SECTION 00 91 01

ADDENDUM NO. 1

BUILDINGS 5 & 6 RENOVATIONS
 San Mateo County Community College District

CAÑADA COLLEGE
 4200 Farm Hill Boulevard
 Redwood City, CA 94061

3/4\"/>

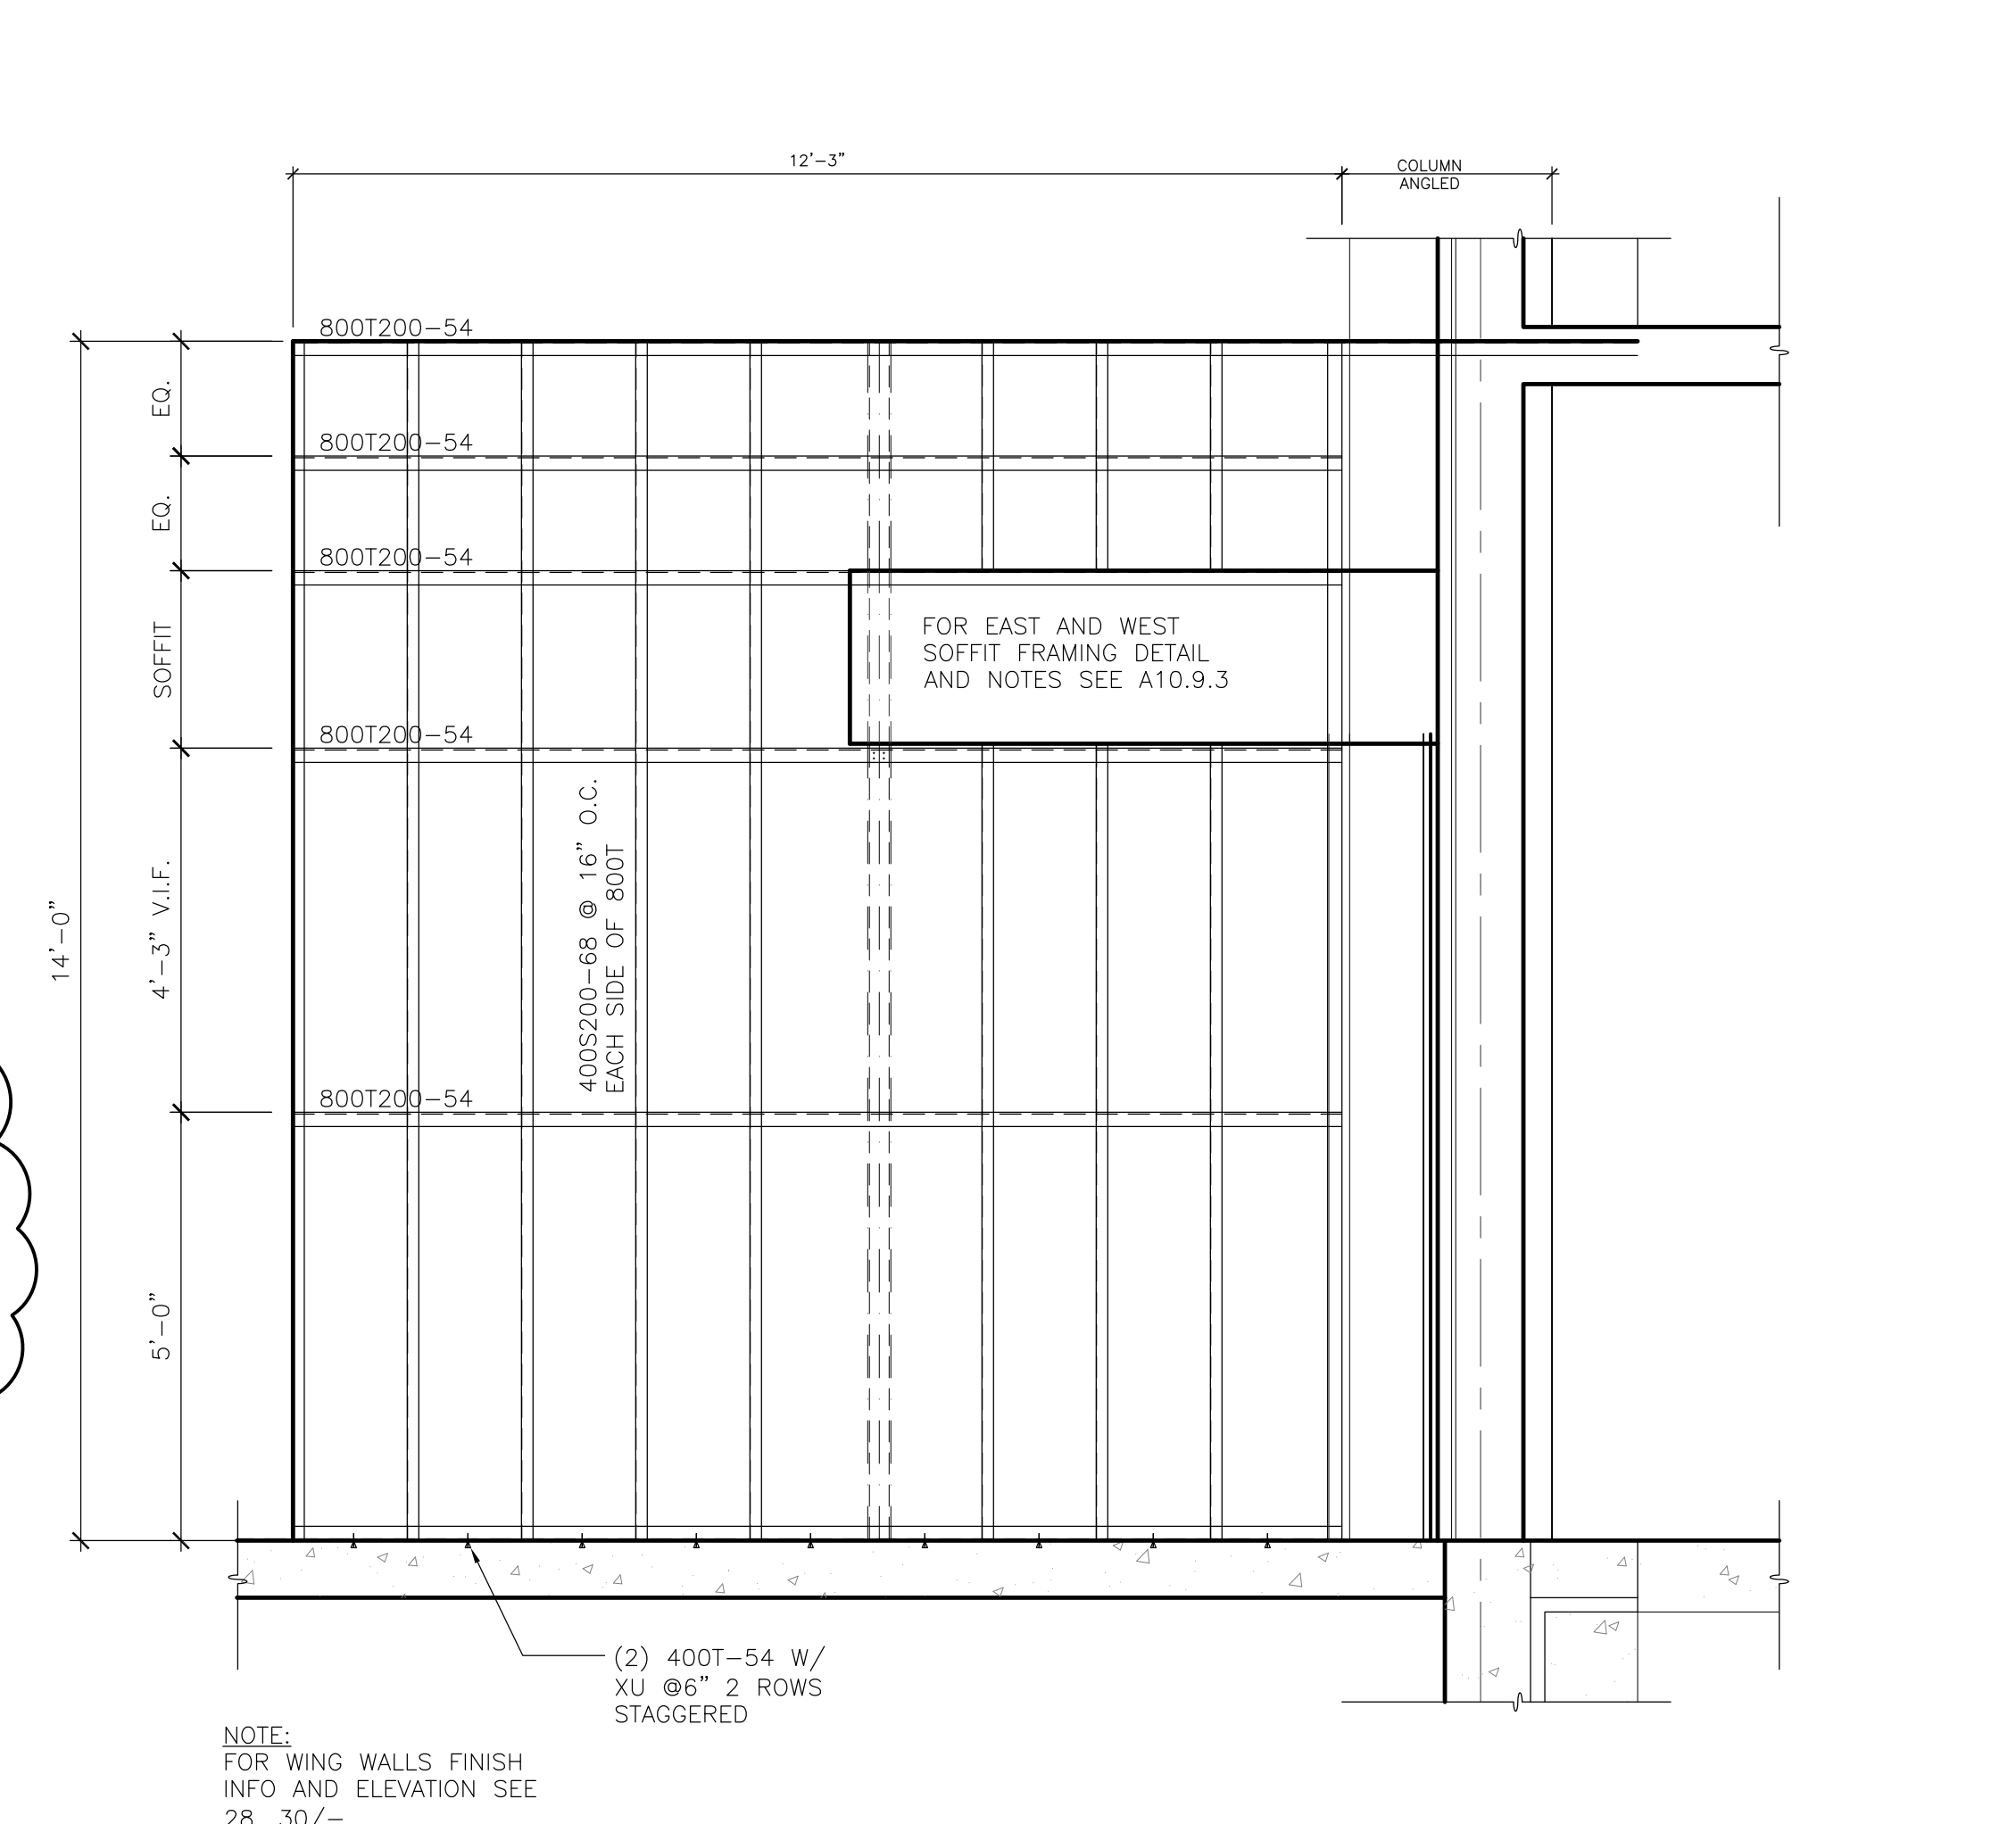
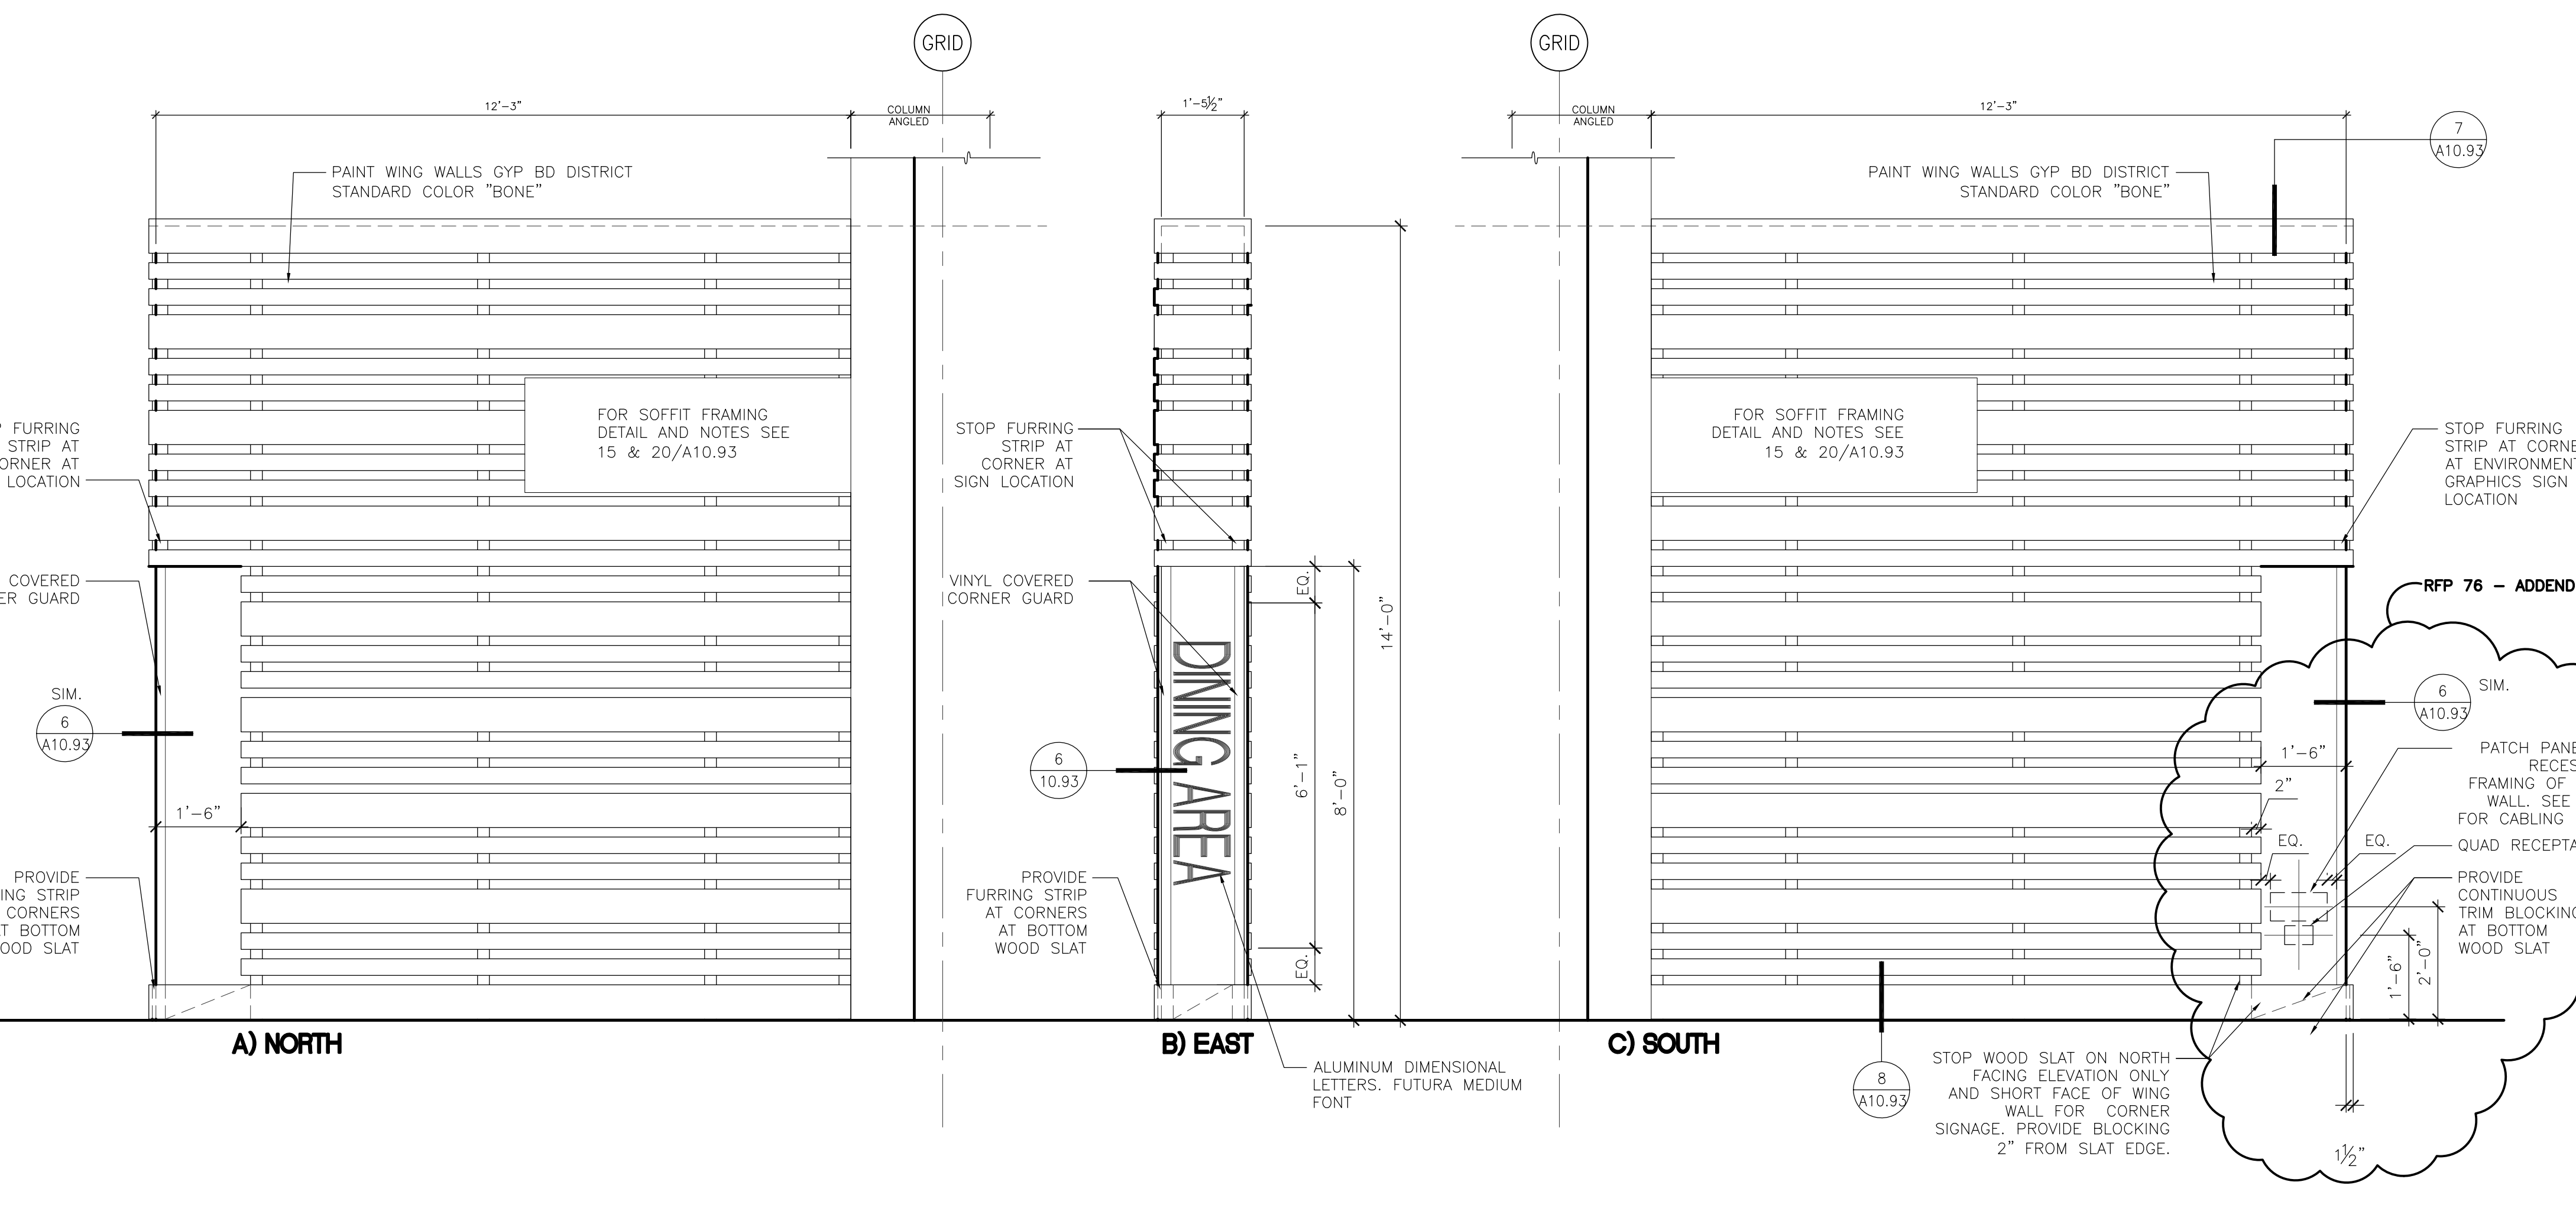
10. Drawing A10.94R – Wall Types and Casework Details
 - A. Revise Detail 30, as shown on attached Drawing A10.94R.
11. Drawing M2.3d – Mechanical Ductwork Plan – Third Floor.

Drawing Number
M2.3d

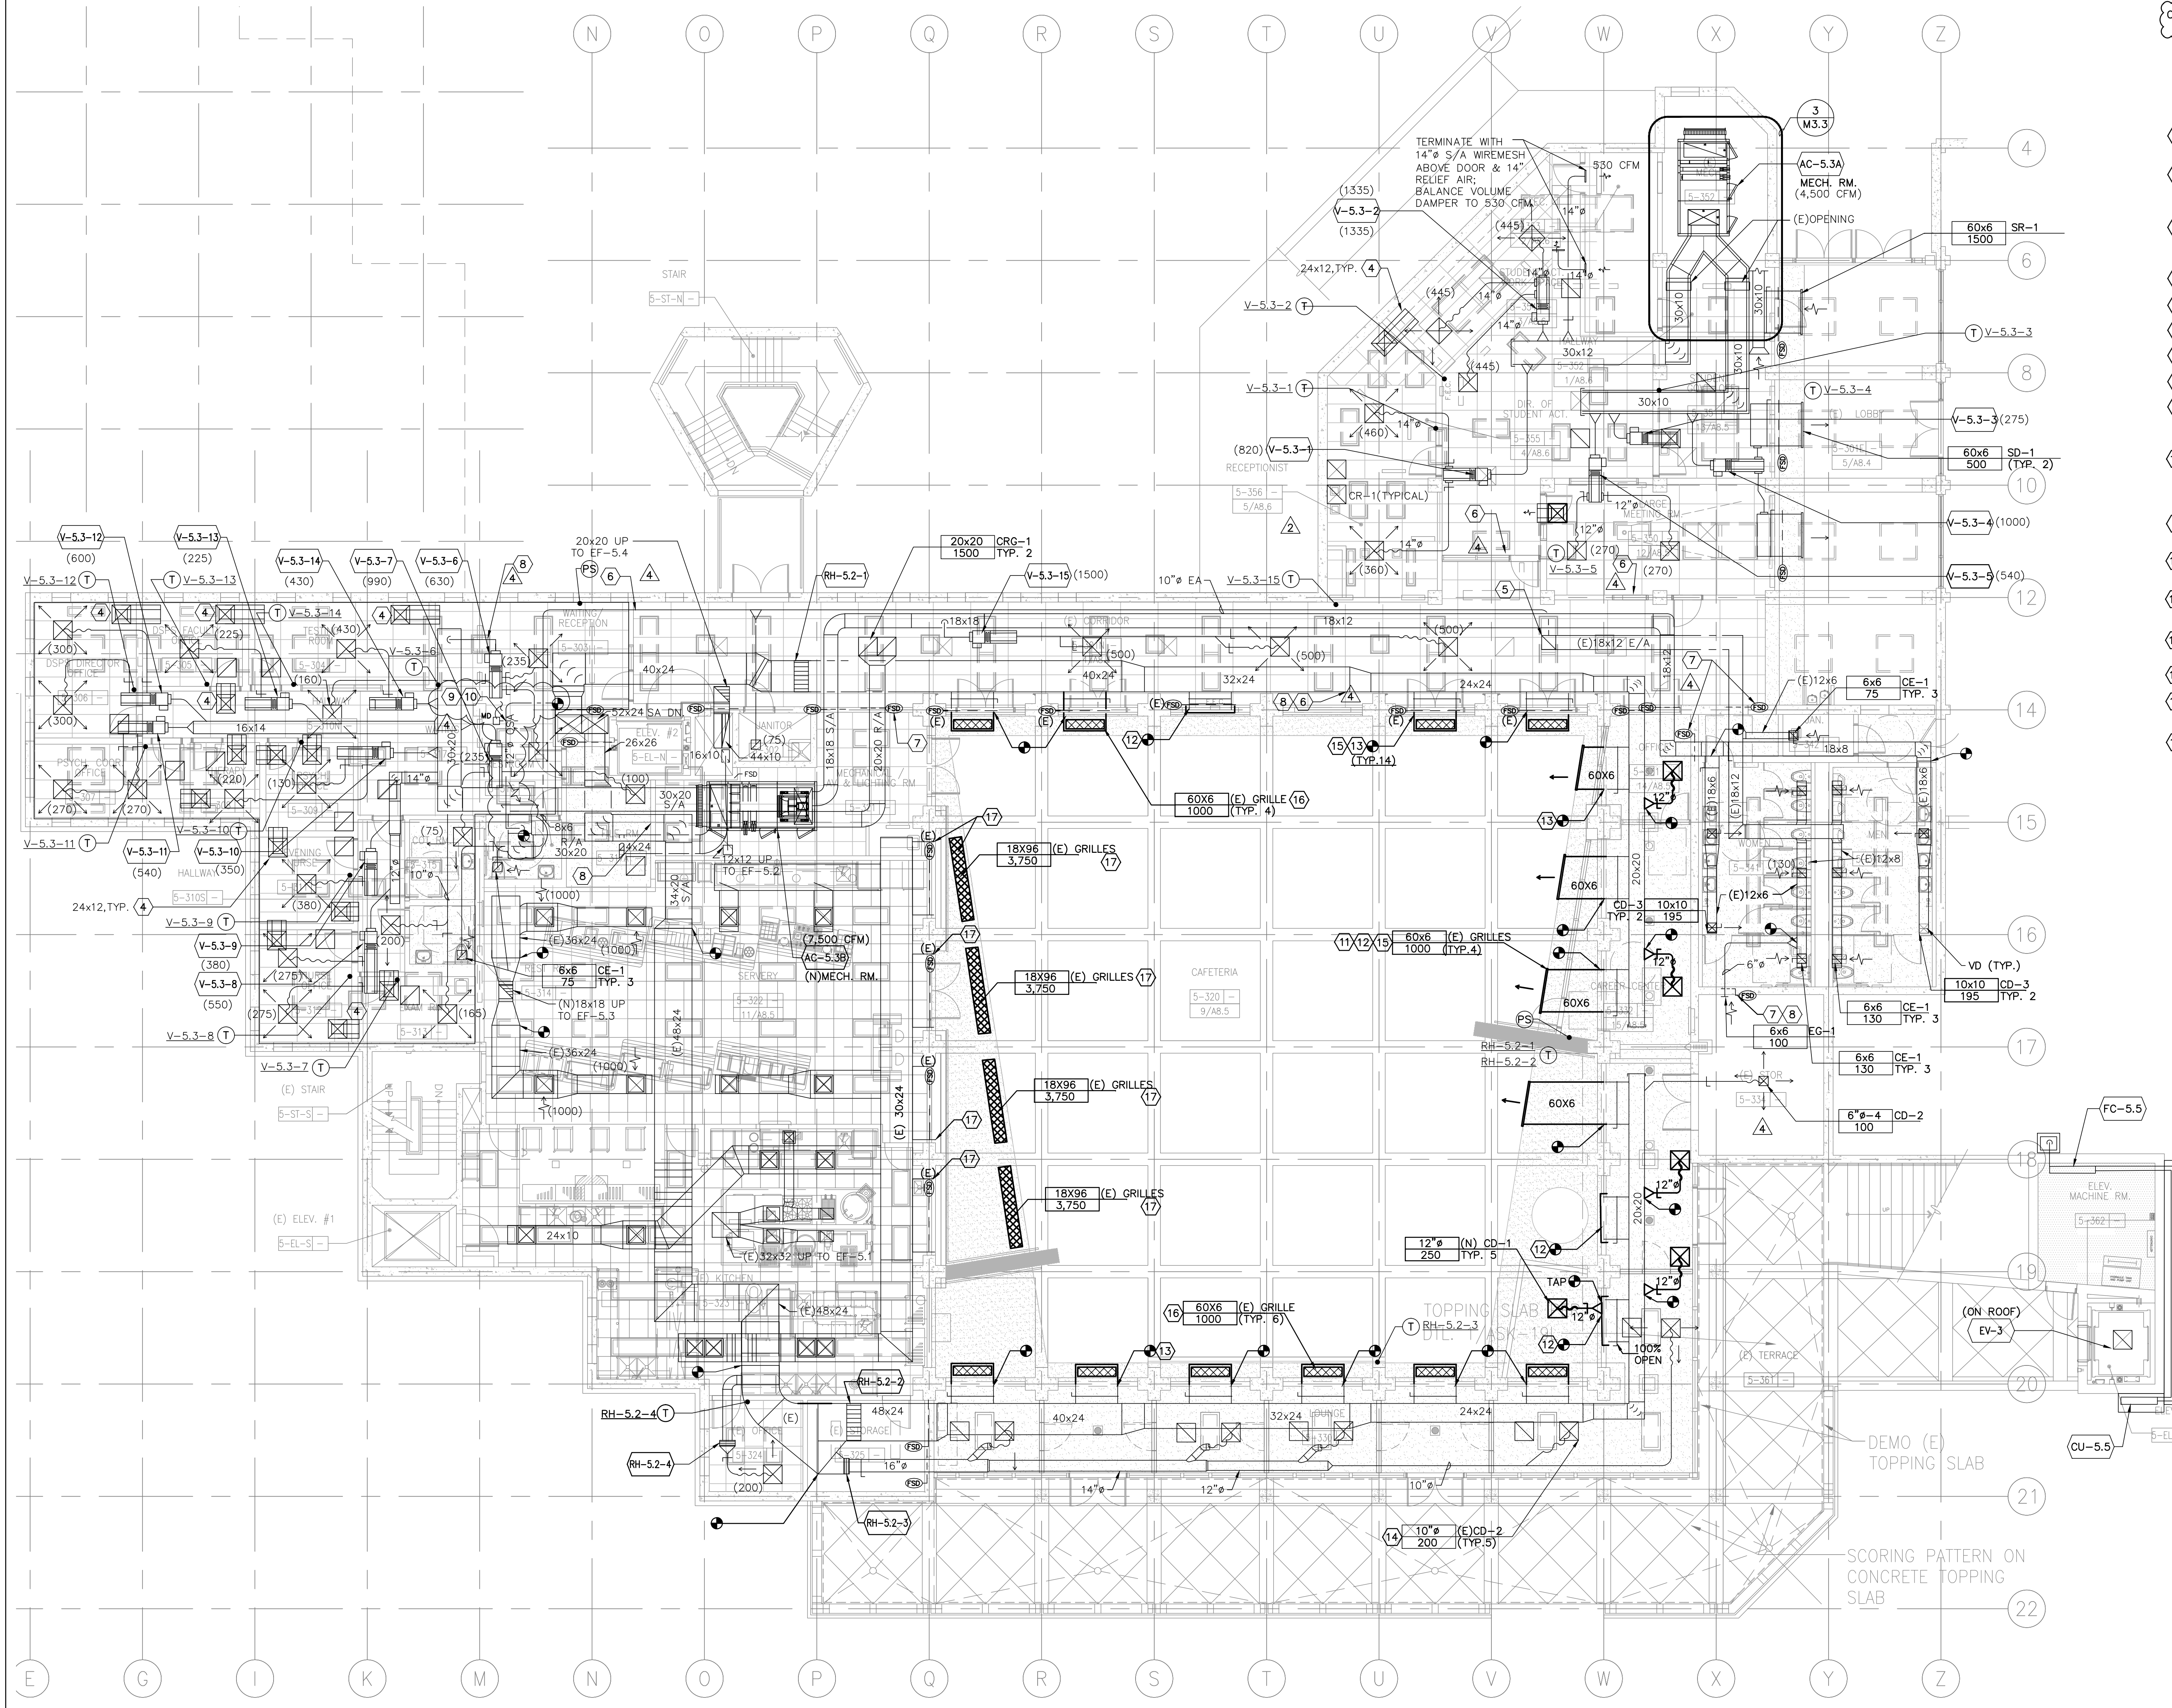
- A. Added General Sheet Note C, as shown on attached revised Drawing M2.3d.
12. E0.2 – Luminaire Schedule & Title 24 Calculations
 - A. Modified drawing as shown on attached revised Drawing E0.2:
